1. To supplement Attachment B, please explain how SROG will monitor the pipeline between the Little Willow Facility and well DJS 2-14 to prevent leaks and/or spills.

2. *The application states on page 10 that a complete water flow testing and water analysis was done for two existing wells prior to developing the Willow Field. Data are presented for one of these two wells. To supplement Attachment E, provide the name, location, or value of Total Dissolved Solids for this other well.*

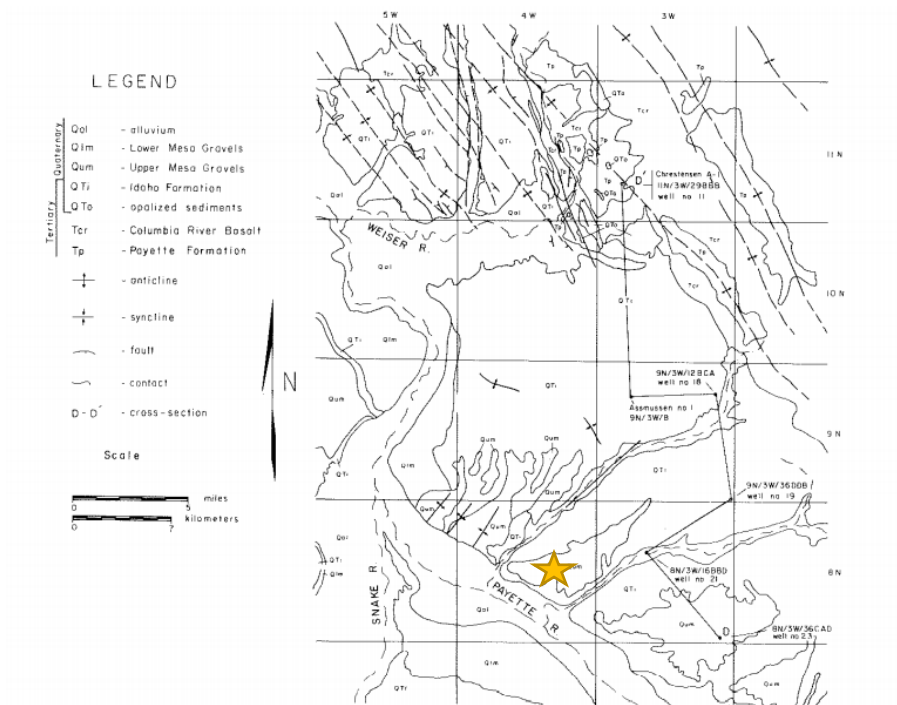
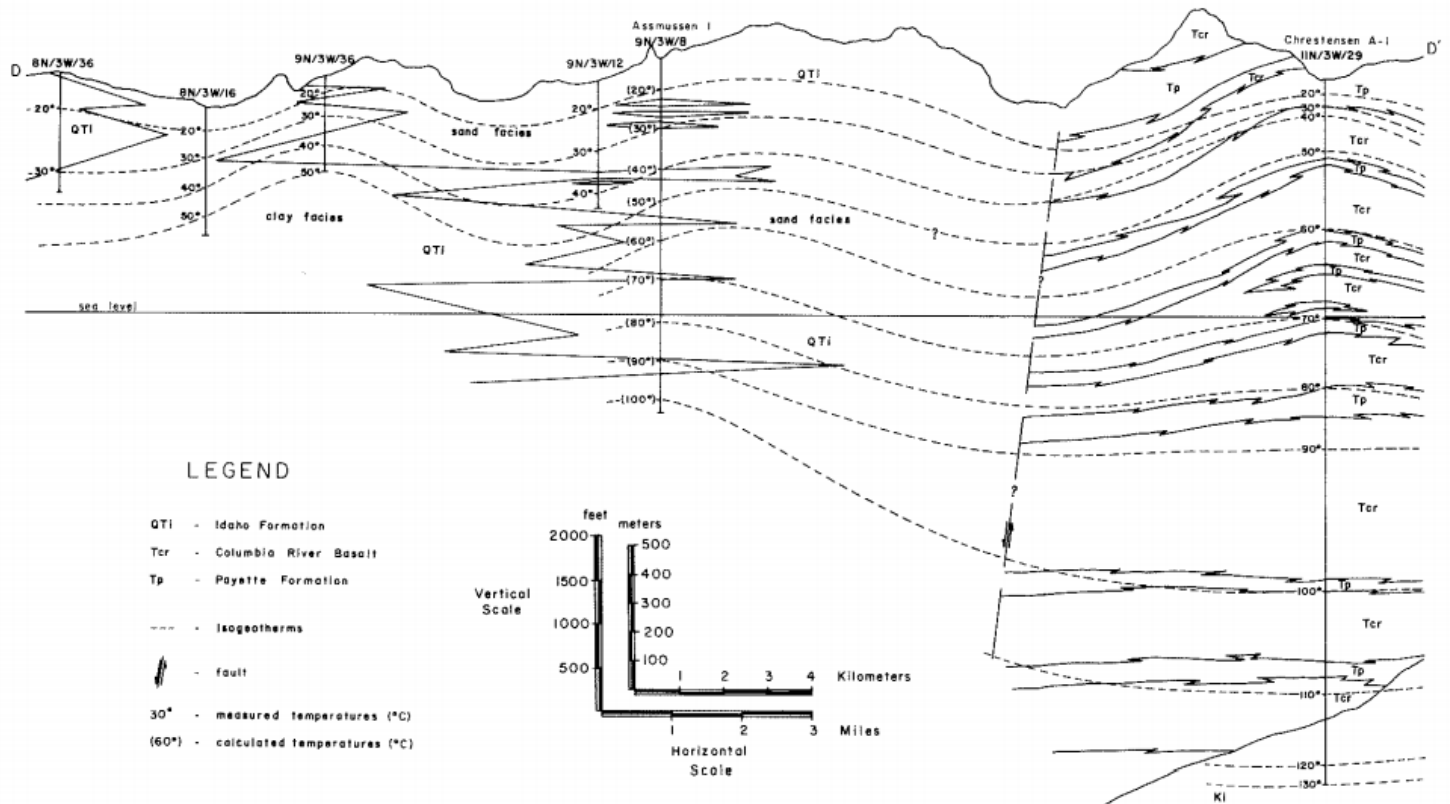
11. To supplement Attachment G, detail whether there are any known fluid transmission routes between the Willow Sands and basement rock.

A separate type of evidence to consider in addressing the transmissibility question is empirical geothermal data. The Idaho Dept. of Water Resources has a long running Geothermal Investigations in Idaho series. The department studied the area of the proposed permit in Water Information Bulletin No. 30, Geothermal Investigations in Idaho Part 11, 1981. The report presents a cross section (Fig. 11-2) and map (Fig. 11-1) from the area of the Chrestesen well extending down to southeast of the proposed injection well. The report concludes that there is very little groundwater movement in the sediments of the Idaho Group (Chalk Hills and Glens Ferry) in the area around the proposed injection well. This conclusion implies no upwelling fluids from basement rocks.

In figure 5-15, plotted isogeotherms show that near-surface topography affects the subsurface temperatures causing the isogeotherms to parallel the ground surface. In the Christensen A-1 well, No. 11, the isogeotherms appear to be crowded beneath the Payette Formation which overlies the basalts. This is interpreted to be an expression of upward-moving groundwater convecting deep temperatures toward the surface. Farther to the south, the temperatures of holes drilled in the Idaho Group indicate very little groundwater movement (linear temperature gradients) and the isogeotherms are evenly distributed.

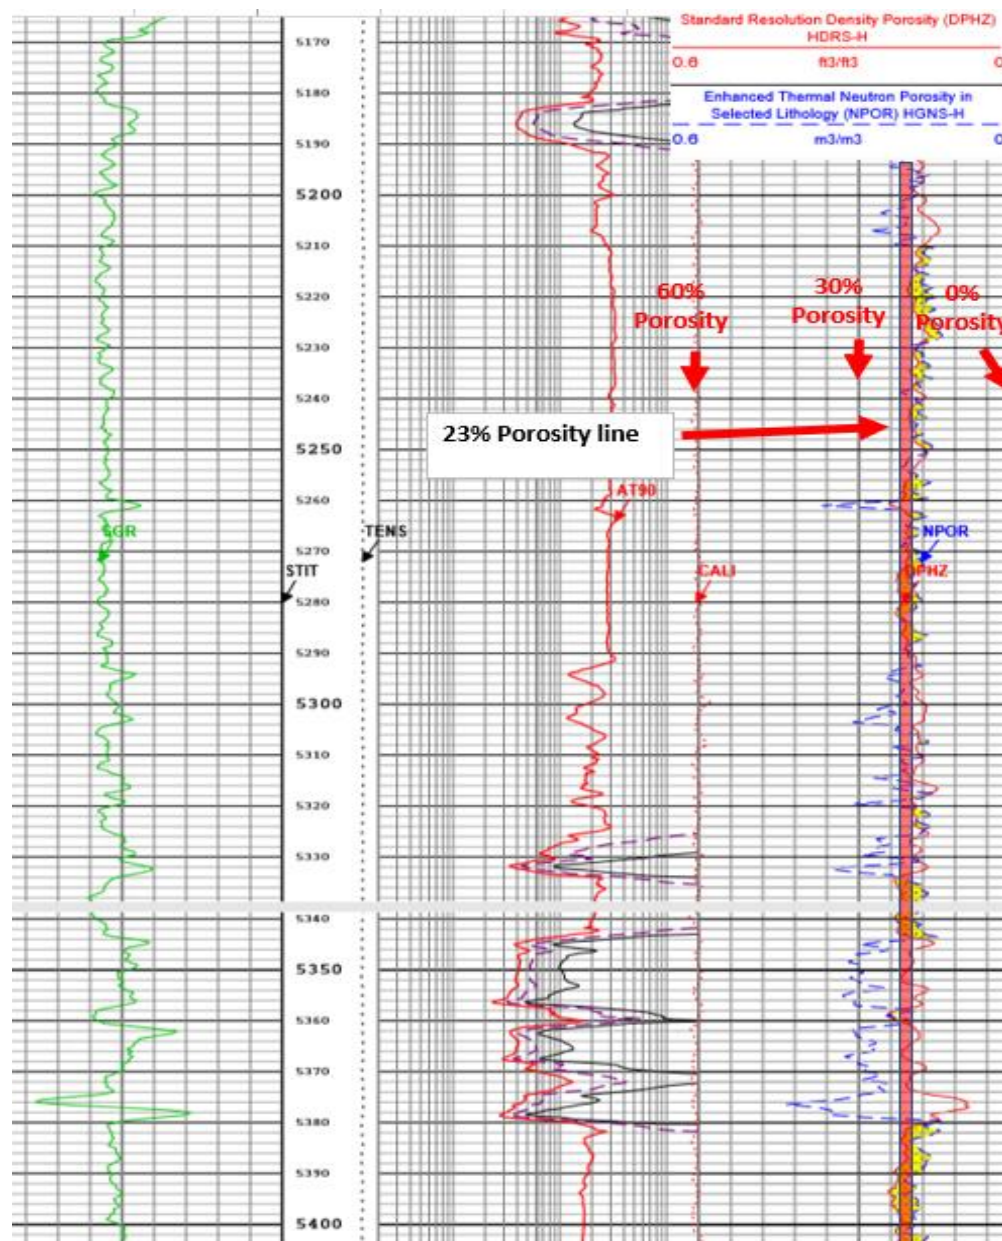
13. To clarify Attachment H, explain how the porosity of the injection zone was estimated and indicate how many data points were used to make this estimate?

- a. The 23% porosity value was chosen by performing a general visual inspection of the Schlumberger Triple Combo Density-Neutron Porosity – Propagation Resistivity Log (open hole log 9/18/14). Density and Neutron curves were evaluated throughout the entire Willow sand section from 4910' – 5390' (proposed Inj zone). These curves suggest that the porosity, in general, range between 21% and 24%. Using a 23% value porosity is a reasonable measurement and provides a conservative approach when used in the volumetric calculations completed in the hydraulic model (Att H-1). See log section below Figure 13-1:
